# CLEMENT J. ZABLOCKI VA MEDICAL CENTER
# CLC ROAD LOOP FINAL WEAR COURSE

## CONSTRUCTION DOCUMENTS
## 11 SEPTEMBER 2015

# AMENDMENT 008
# AVAILABLE DRAWINGS

Project Number: 695-16-113

Drawing Number: C100

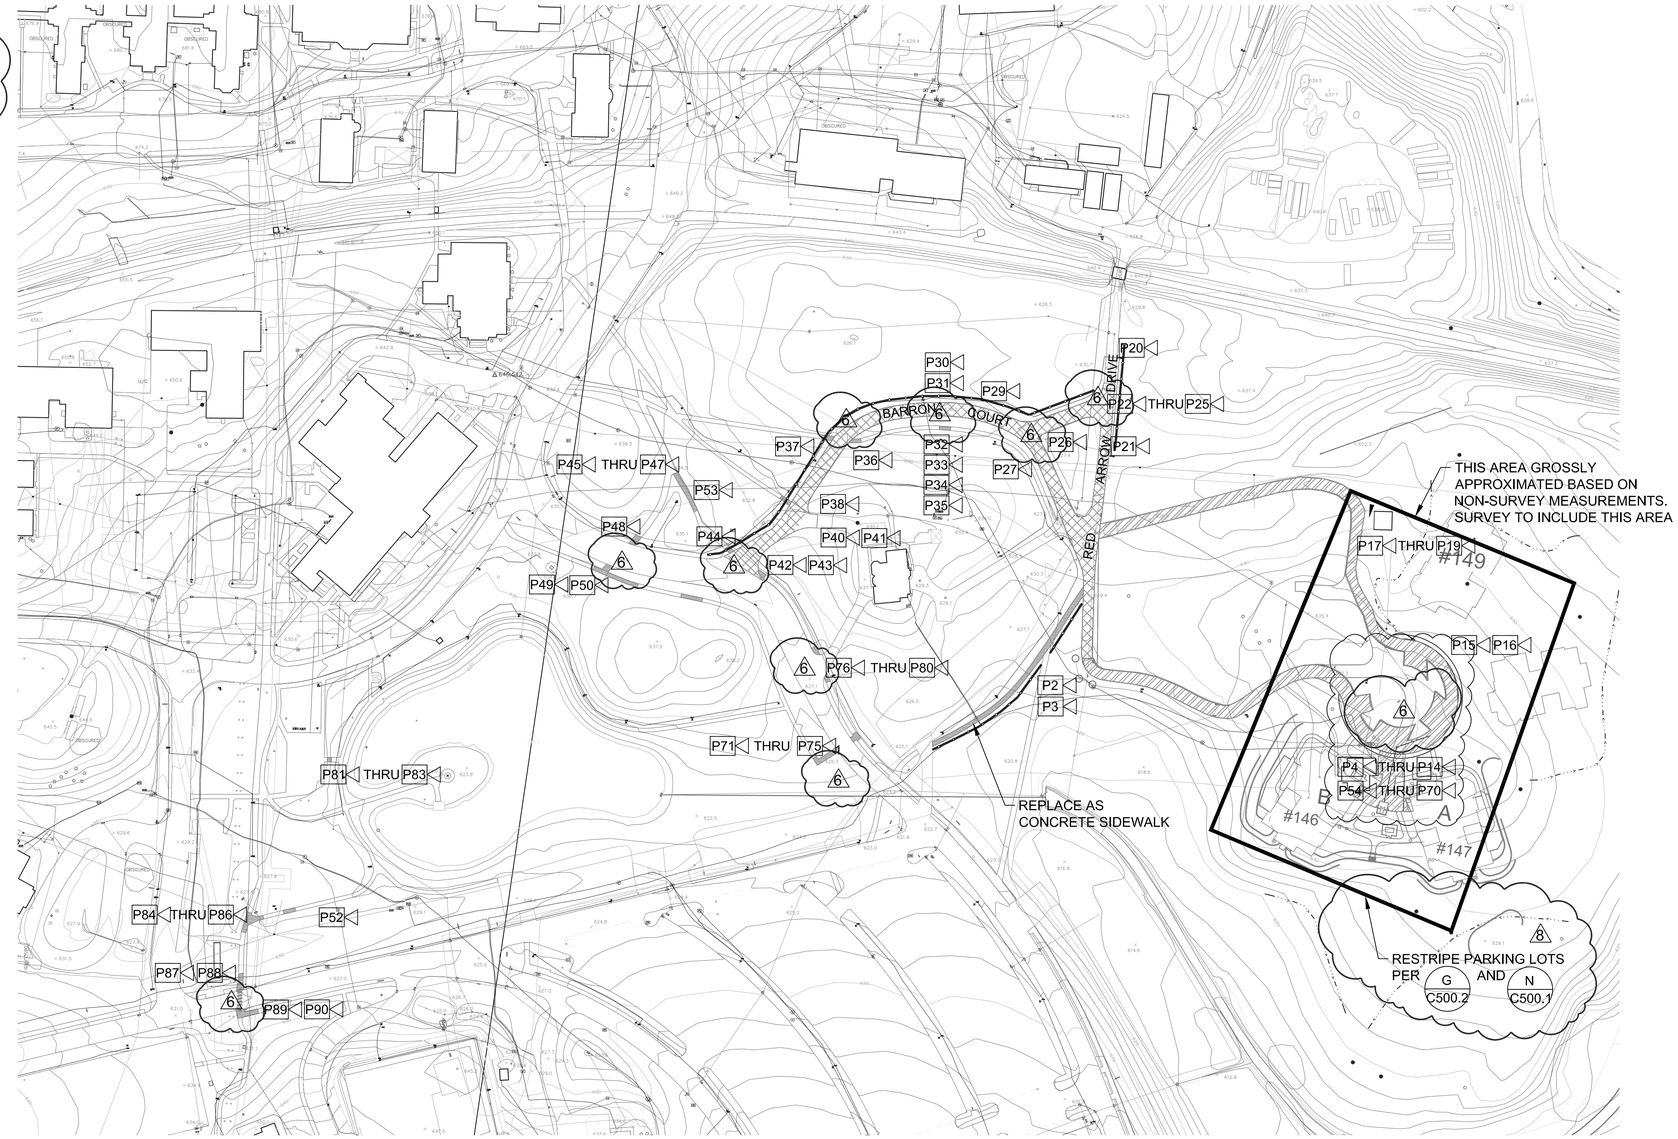
DELETED NOTE TO FIELD VERIFY DIMENSIONS .

Drawing Number: C300

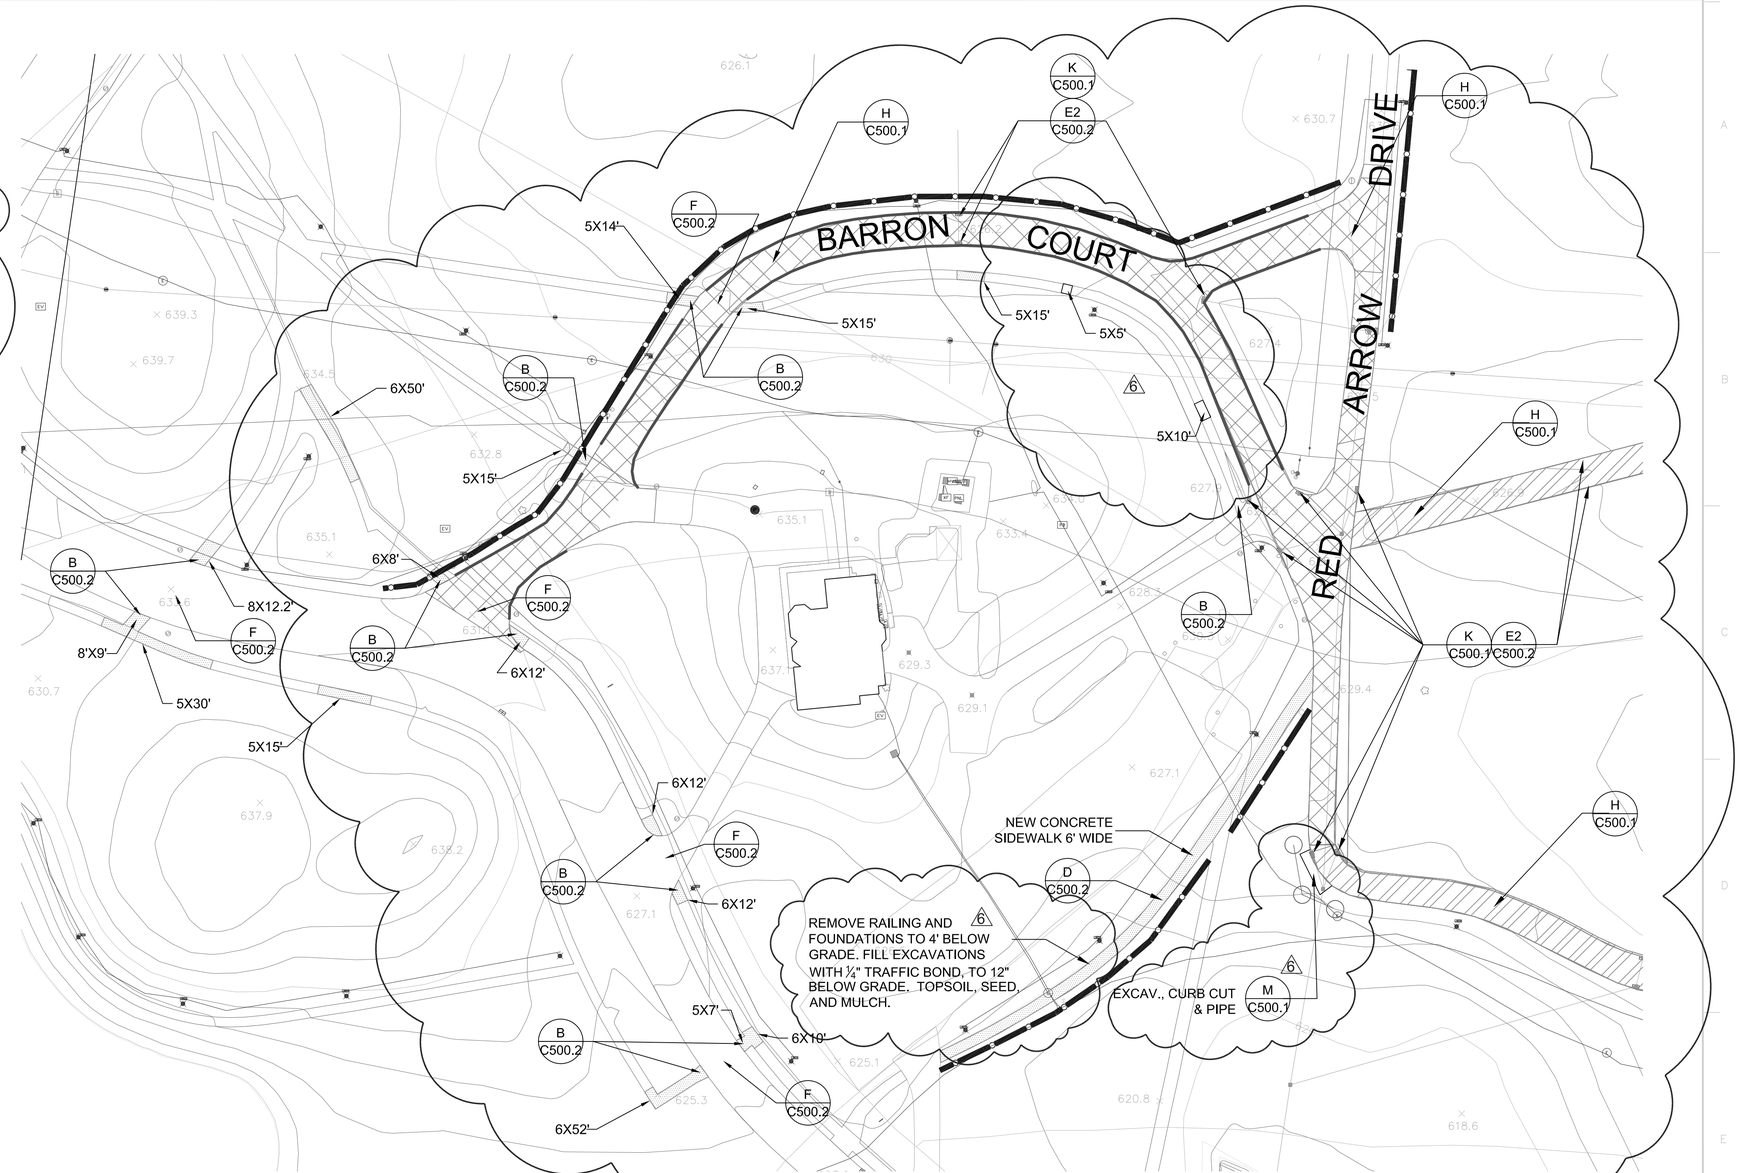
3. BID ALTERNATE 1 DEDUCTS ASPHALT CURB REPLACEMENT, EXCEPT AT RAMPS. 8

BID SIDEWALK TO DIMENSIONS SHOWN. VERIFY LOCATIONS WITH COR 8

Drawing Number: C400

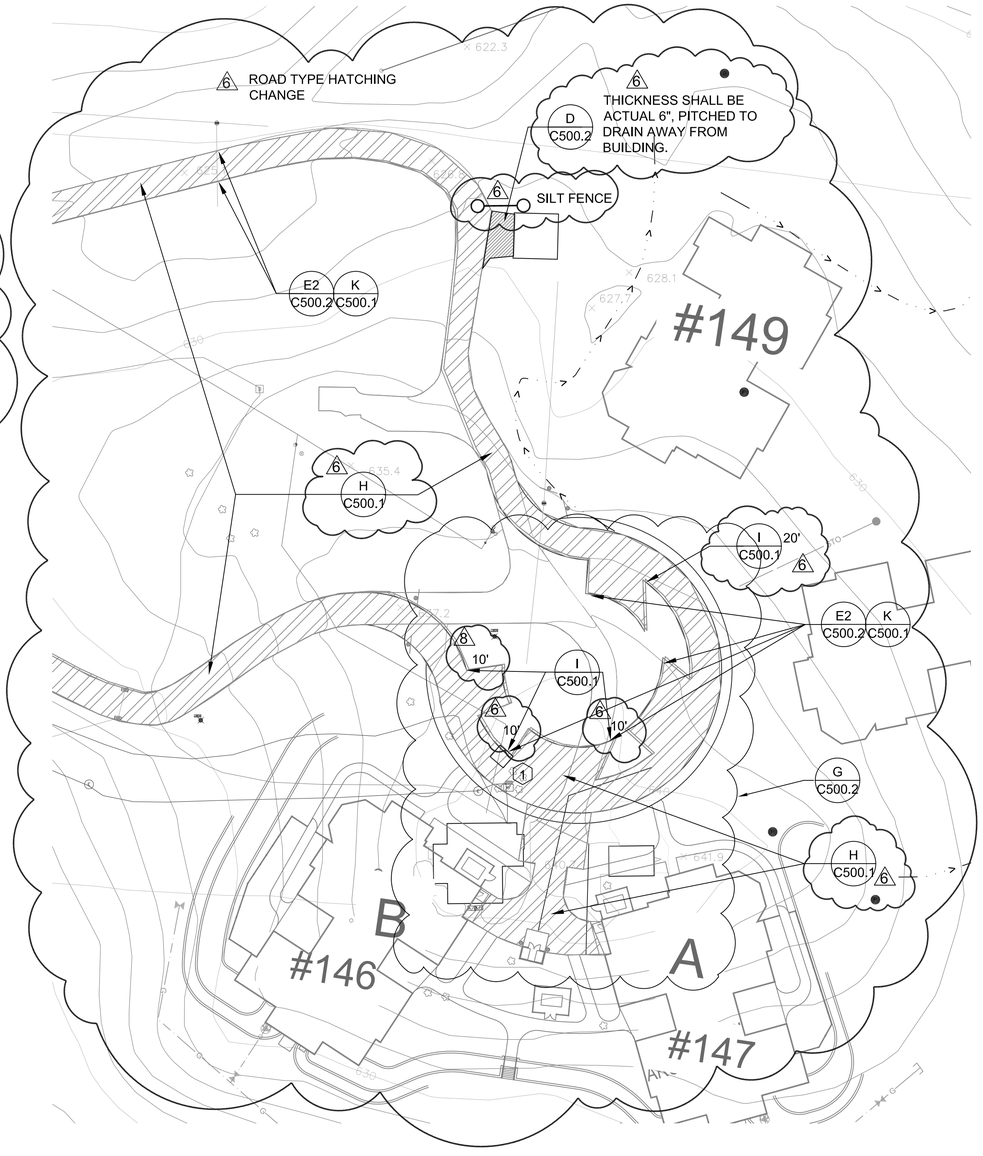
DELETED NOTE 3.

1 EXCAVATE TO EXPOSE 2' AROUND 10'X10' VAULT. BREAK AND REMOVE VAULT WALLS AND FILL MATERIAL INSIDE IT TO 4' DEPTH.

FILL VOID WITH FLOWABLE FILL PER SPECIFICATIONS, TO BASE OF NEW PAVEMENT, REPAIR PER H C500.1 AS CLC ROAD.

Drawing Number: C400.1

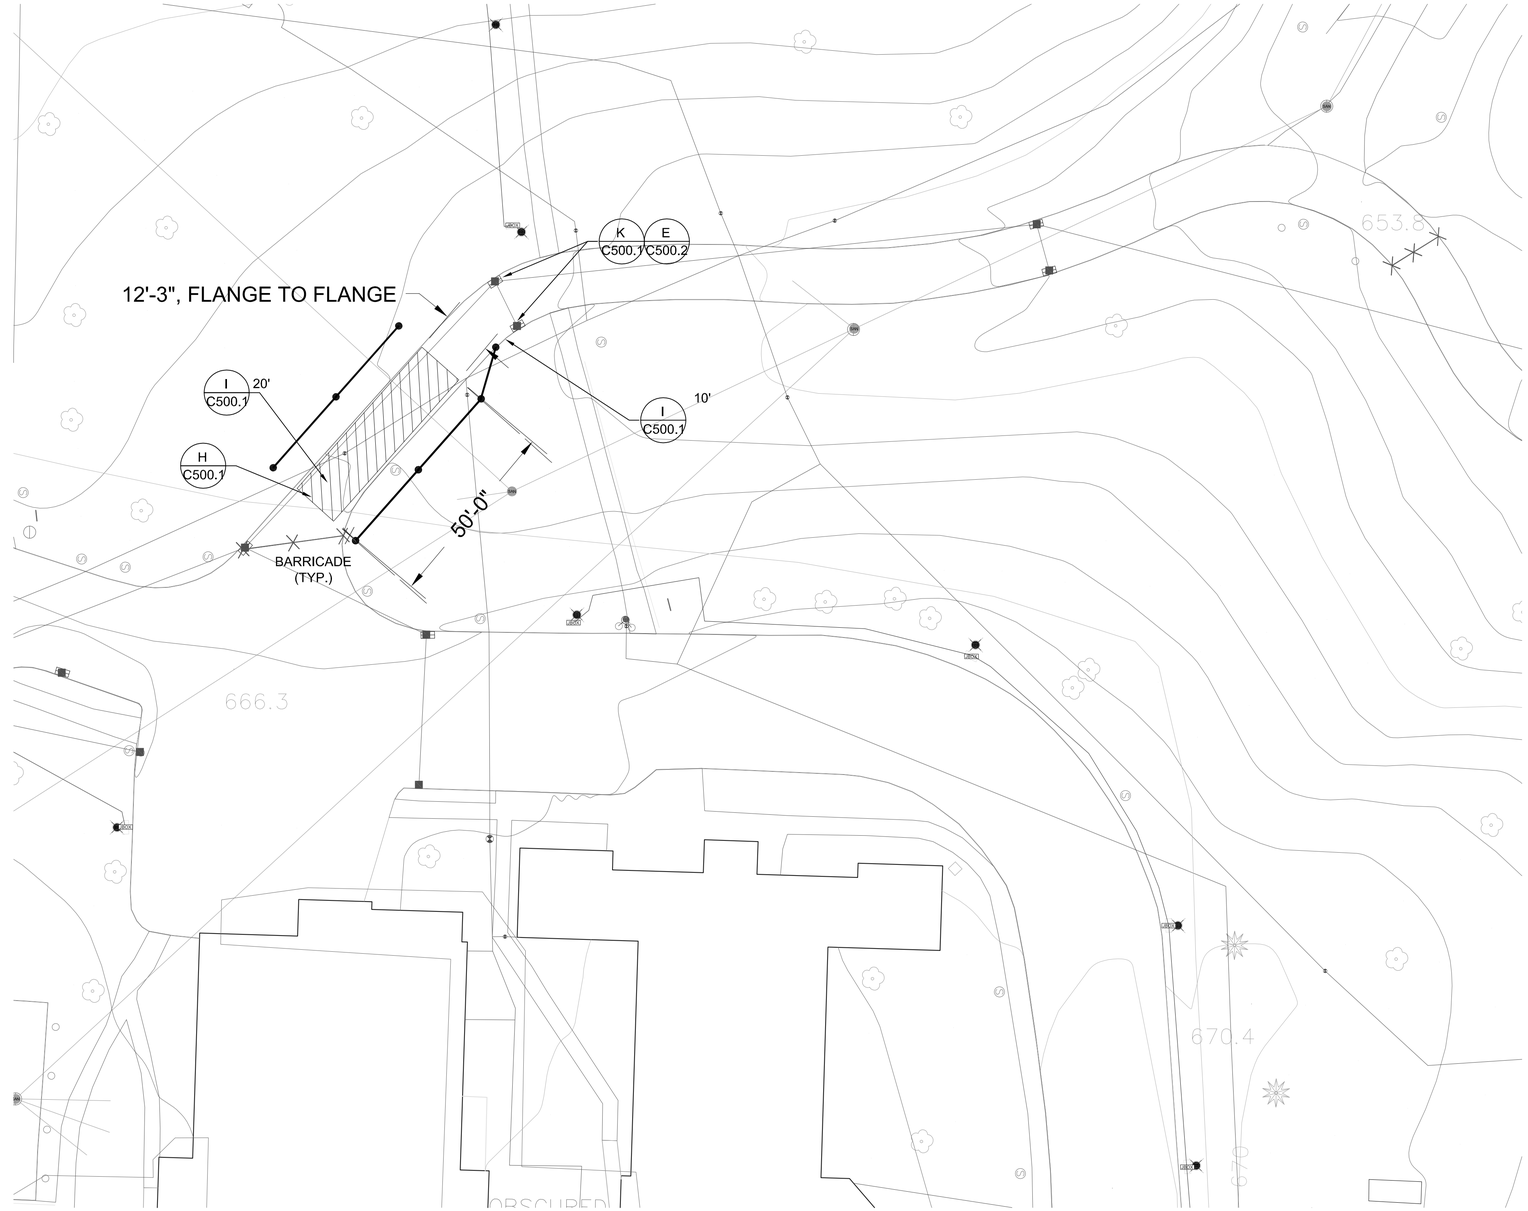
1) MODIFY H/C500.1 TO MILL 4", REPLACE WITH 4" NEW ASPHALT TO MATCH EXISTING GRADE. NO GLASSPAVE 25.
2) WORK SHALL BE WEEKEND WORK.
3) PROVIDE DETOUR SIGNAGE.

Drawing Number: **C400.2**

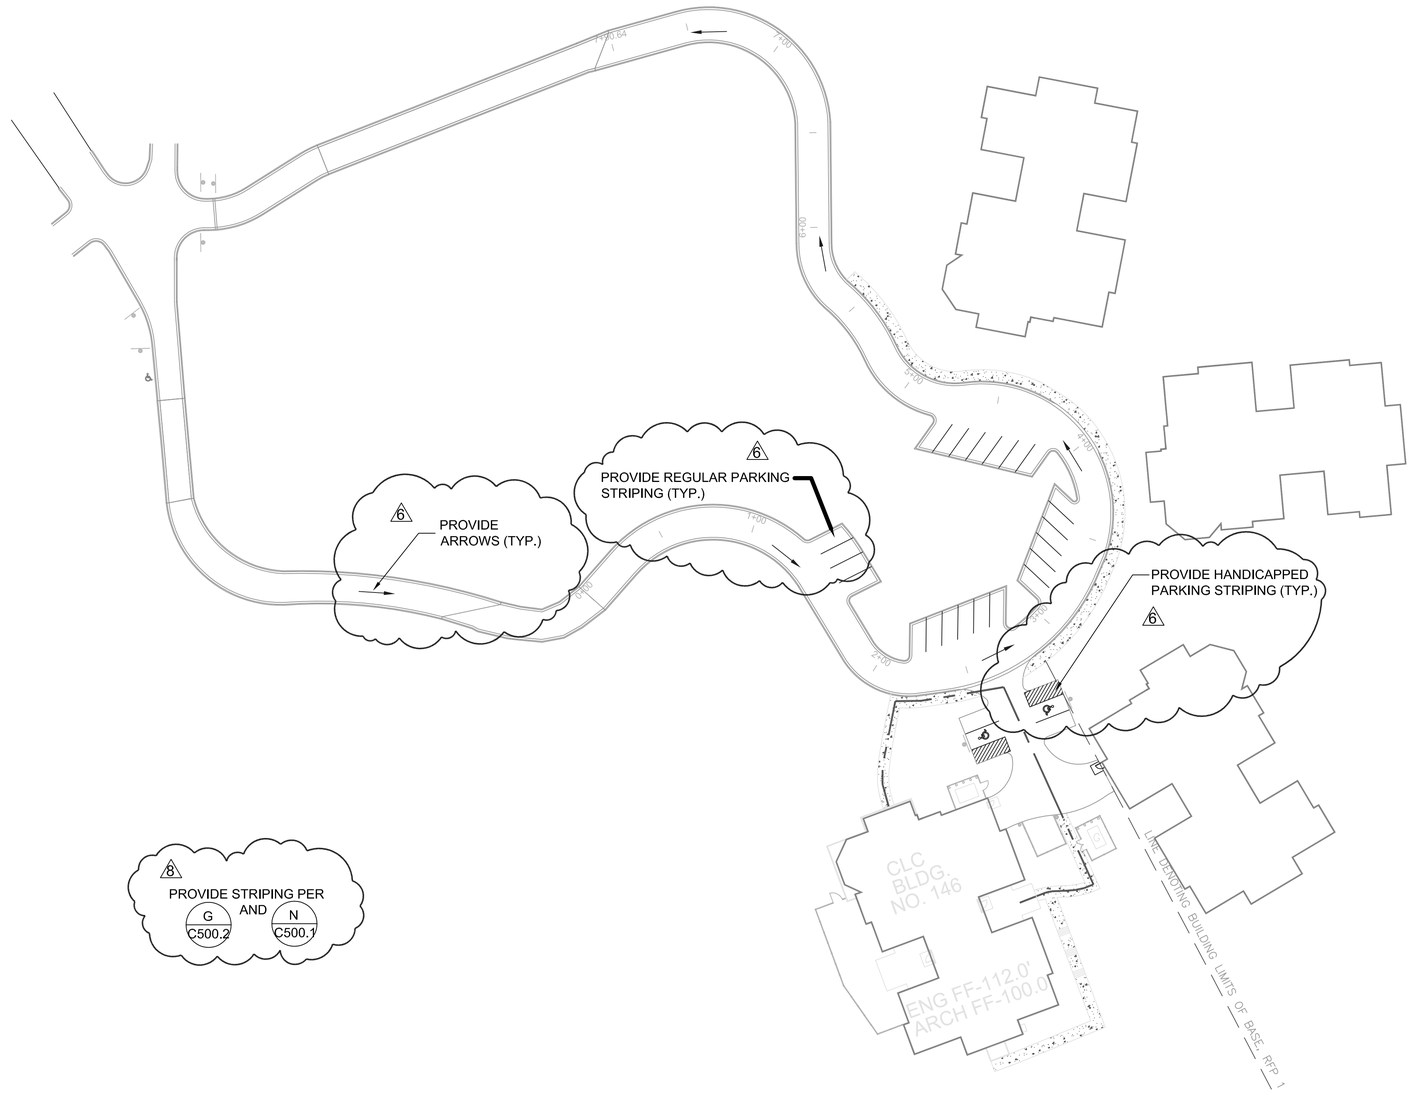
DELETED NOTE TO FIELD VERIFY DIMENSIONS .

CC PAVEMENT SECTION OLD ROADS REPLACEMENT (NOT IN CONTRACT)
SCALE: N. T. S.
WORK ASSOCIATED WITH THIS TYPICAL SECTION INCLUDES ASSOCIATED DEMOLITION, PREPARATION AND RESTORATION ONCE CONSTRUCTED

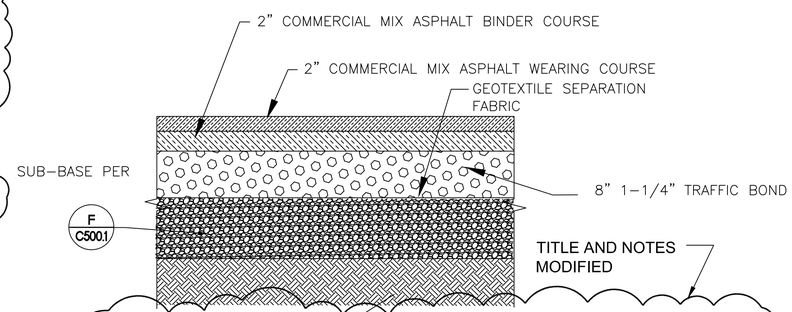
TITLE AND NOTES MODIFIED

IF PROOF ROLL FAILS, EXCAVATE 12" DEEPER, PROVIDE 12" LAYER OF 6" MINUS BREAKER RUN, ANGULAR LIMESTONE, NON-RECYCLED 6

NOTES MODIFIED
